ZONING BOARD OF APPEALS

Review of Plans: Skae Site Plan Building Expansion, 337-339 Blaisdell Road, Orangeburg, NY
Section 76.08 Block 1 Lot 4 LIO zone
This matter is scheduled for:

**PB#18-35: Skae Site Plan
Building Expansion
Preliminary Site Plan Approval
Subject to Conditions/ Neg. Dec.**

**Town of Orangetown Planning Board Decision
September 12, 2018
Page 1 of 12**

SPARACO & YOUNGLOOD, PLLC
 CIVIL ENGINEERING & LAND SURVEYING
 SITE PLANNING
 18 NORTH MAIN STREET
 P.O. BOX 618
 HARRIMAN, N.Y. 10926
 TEL: (845) 782-8845
 FAX: (845) 782-5901
 WWW.SPACOESELSYS.COM
 WWW151@GMAIL.COM
 DATE: APRIL 24, 2019
 SCALE: 1" = 80'
 SHEET: 1 OF 6

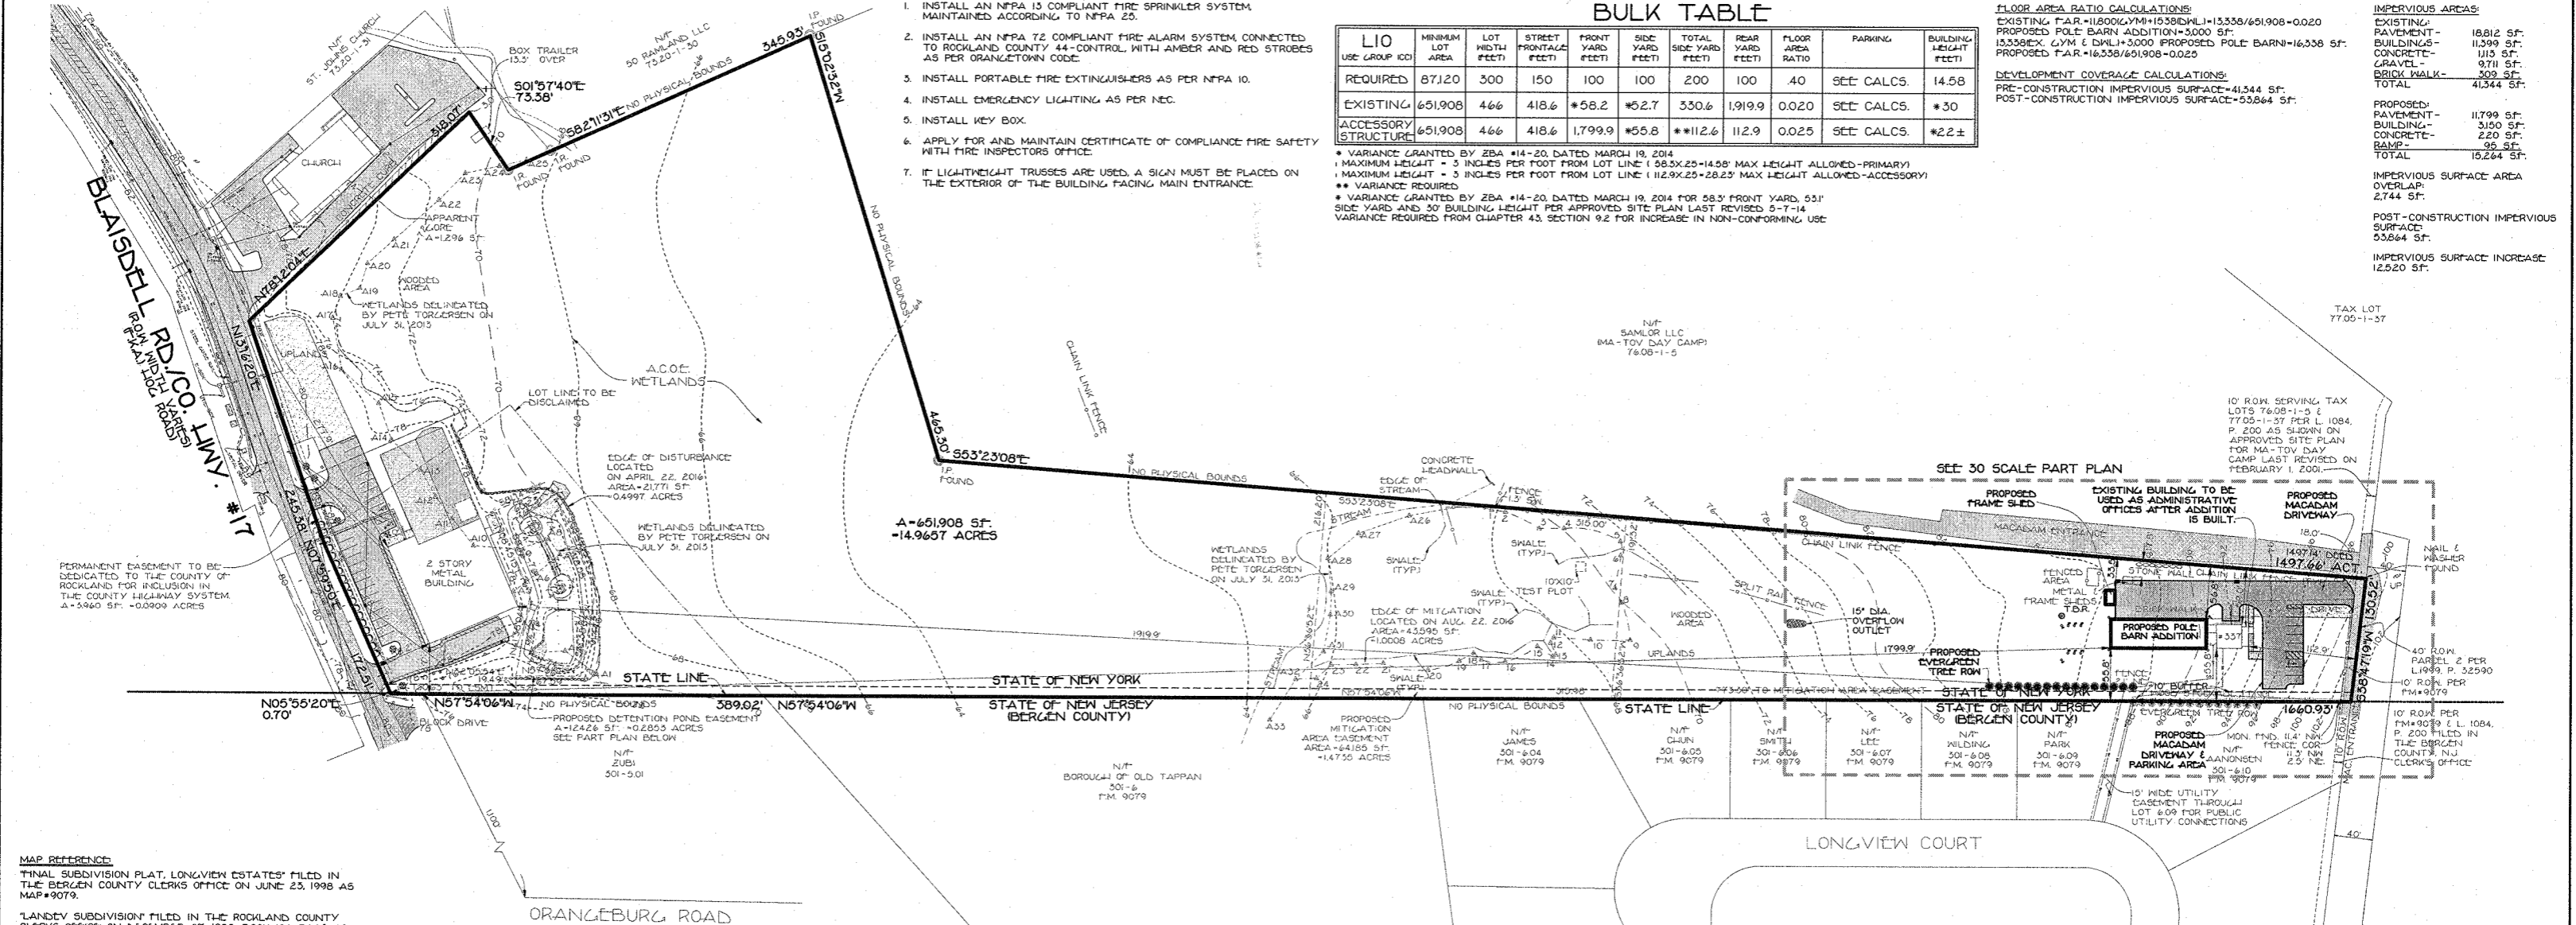
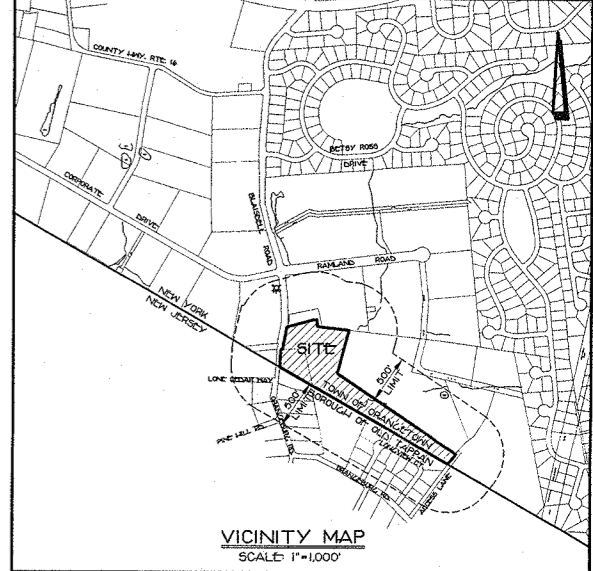
14. The 15 inch HDPE overflow/ outlet pipe and rip rap exhaust area shall be shown on drawing 1 of 3.

DATE: APRIL 24, 2019
SCALE: 1"=30'
SHEET: 2 OF 6

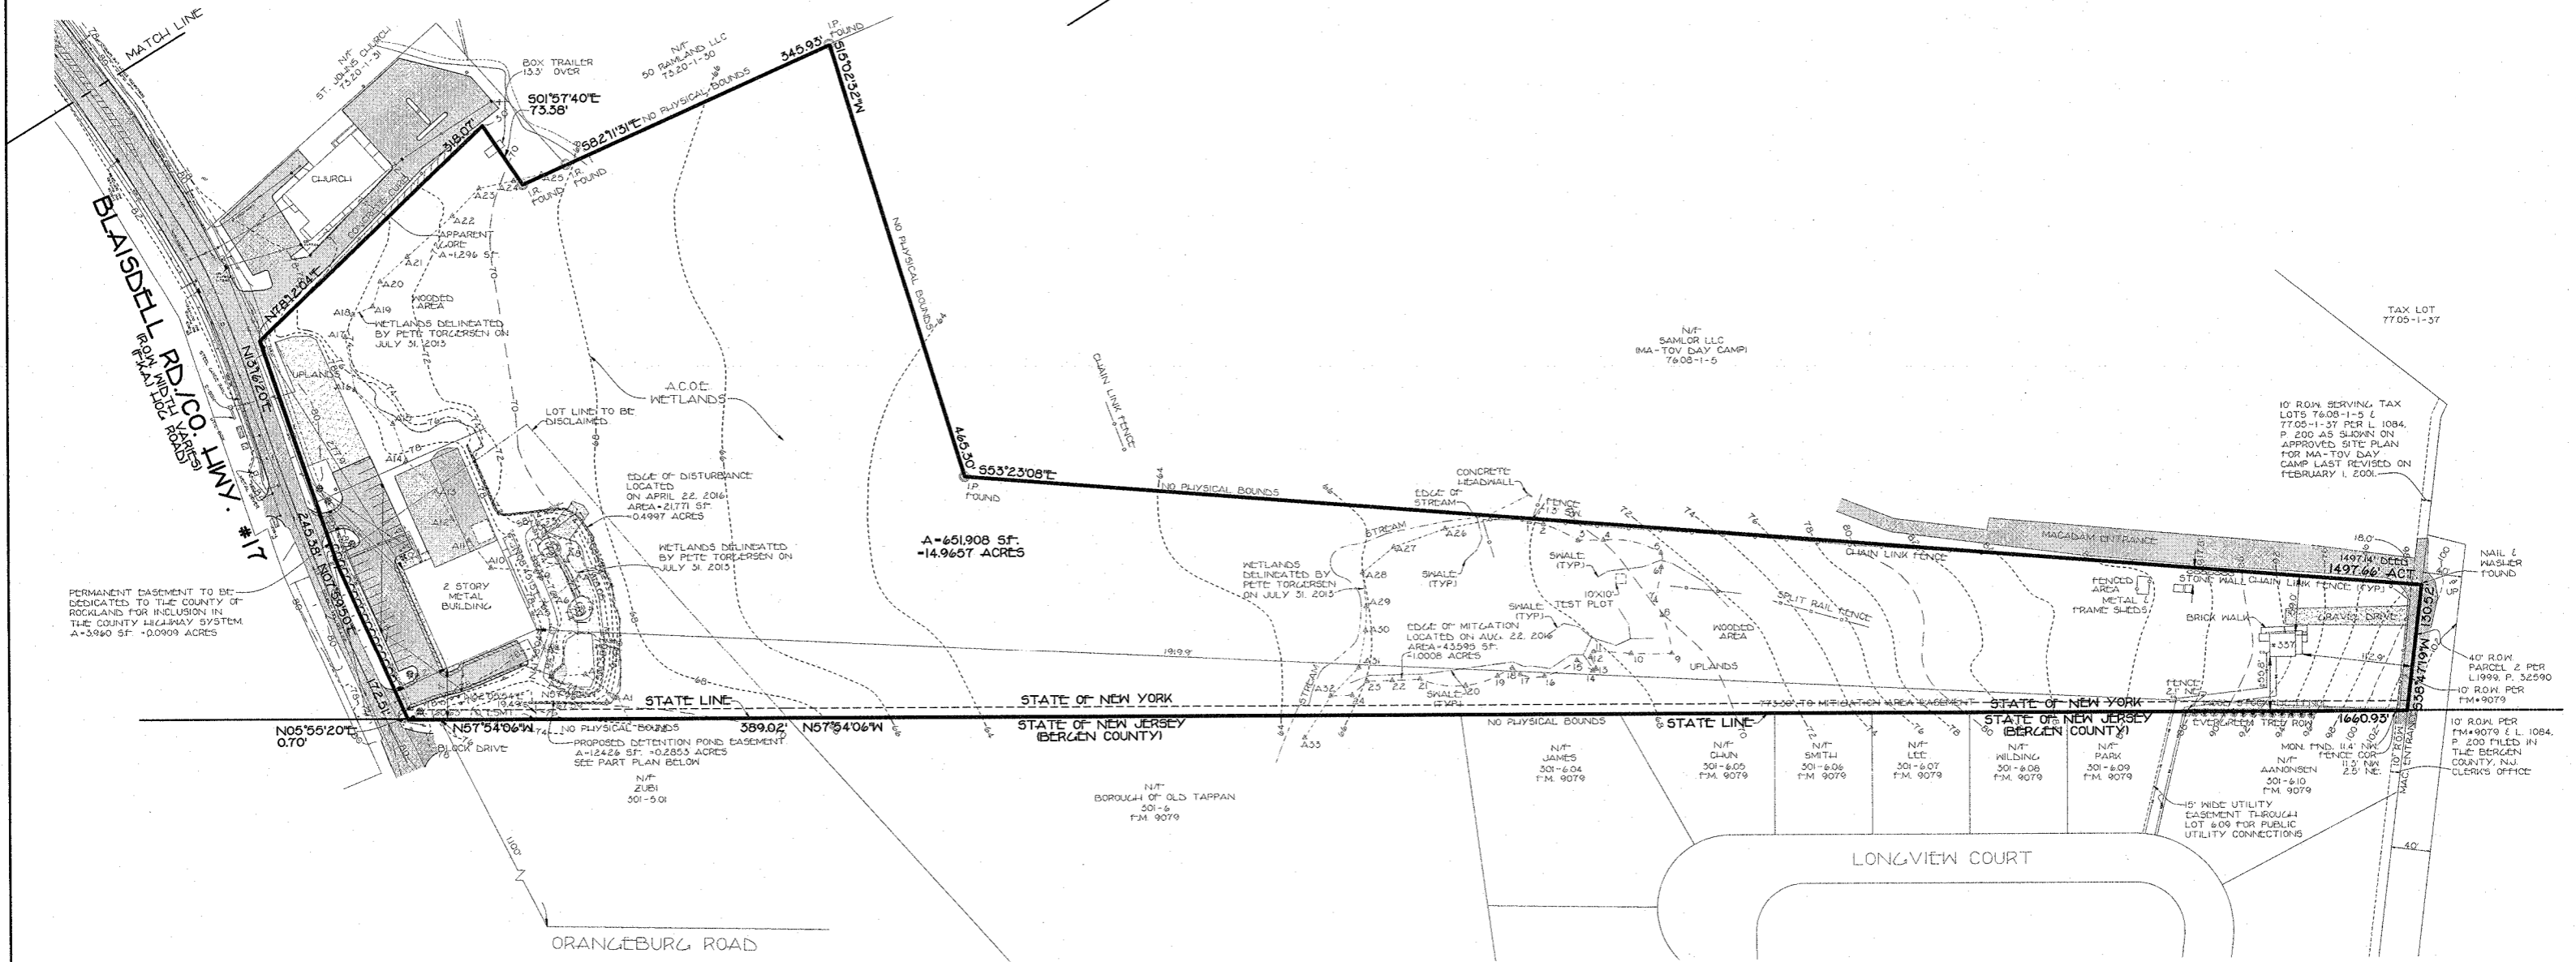
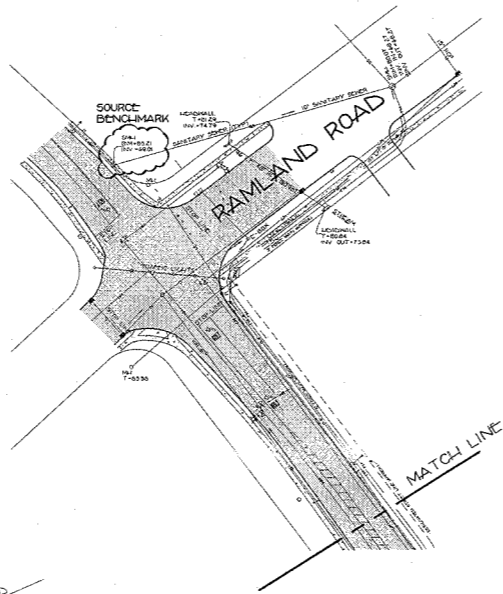
13. The applicant's engineer shall provide calculations showing the existing and increase impervious area for the site. These calculations shall include a tabular breakdown of the total area of disturbance listed on drawing 2 of 3.
